SERVICE NOTICE

**RIDE: GRAVITRON, STARSHIP ALIEN ABDUCTION
AND CENTRIFUGE**

**SUBJECT: TRAP DOOR MICROSWITCH
INSTALLATION**

7W03001

SWITCH INSTALLATION
SHOWN WITH DOOR OPEN

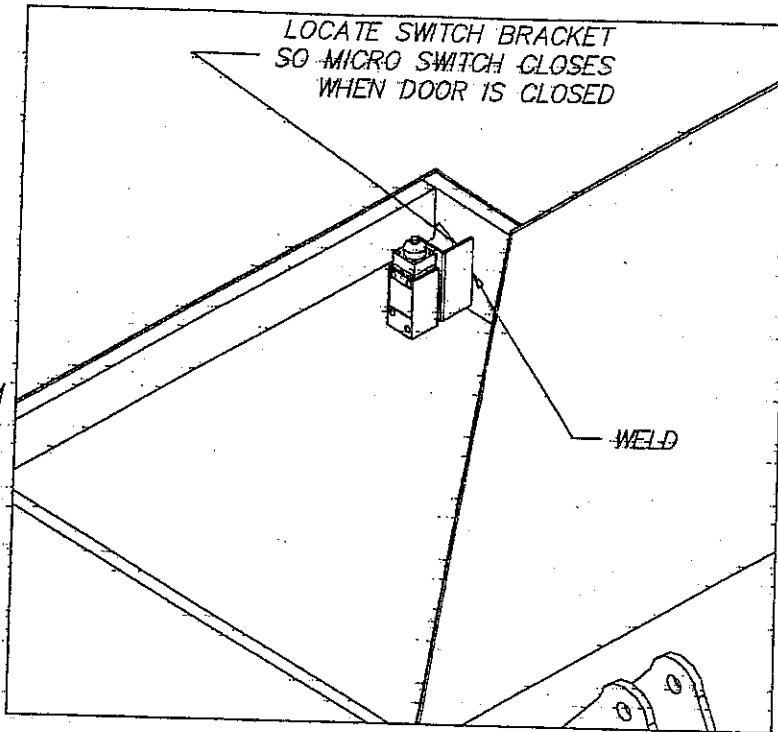
1. REMOVE WHITE WITH RED STRIPE FROM COMMUTATOR.
2. ATTACH TO ONE WIRE FROM MICROSWITCH.

3. ATTACH OTHER WIRE FROM MICROSWITCH TO THE RING THAT THE WHITE WITH RED STRIPE WAS CONNECTED TO.

PART #ESL0001
MICRO SWITCH

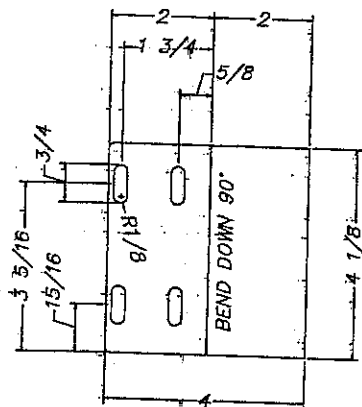
4. WIRES ATTACH TO THE NORMALLY OPEN CONTACTS IN MICROSWITCH.
